PHOTOSIMULATION 3: ROCK POND, T5 R6 BKP WKR

PHOTOSIMULATION 3: ROCK POND, T5 R6 BKP WKR, Structure 731-735 Visibility Analysis

PHOTOSIMULATION 3A: ROCK POND, T5 R6 BKP WKR

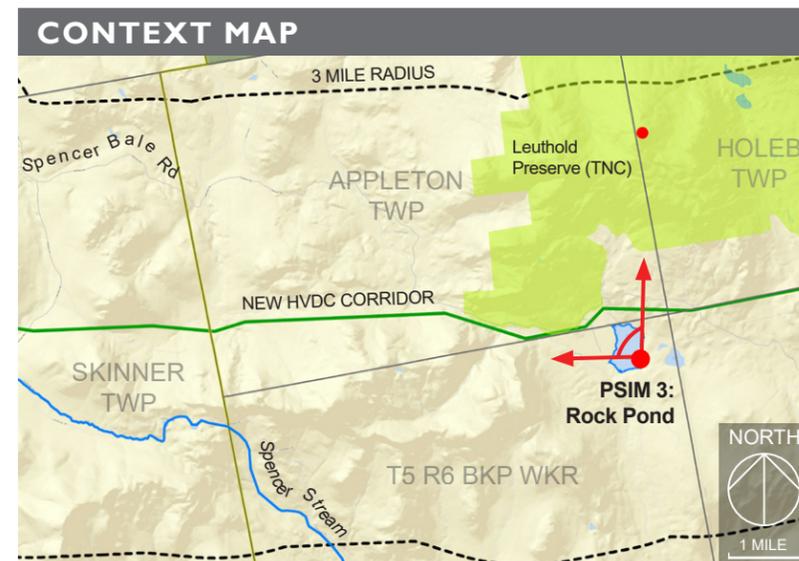
This simulation reflects a change in height for five structures in proximity to Gold Brook on the northern shoulder of Three Slide Mountain. Full vegetation height will be preserved for approximately 4,269 feet of corridor to maintain habitat. An additional 2,059 feet of corridor would be maintained using a tapering vegetation management technique which allows vegetation at heights ranging from 15 feet to 35 ft to be preserved along both sides within the corridor. This mitigation would minimize the visual 'notch' potentially viewed from Rock Pond.
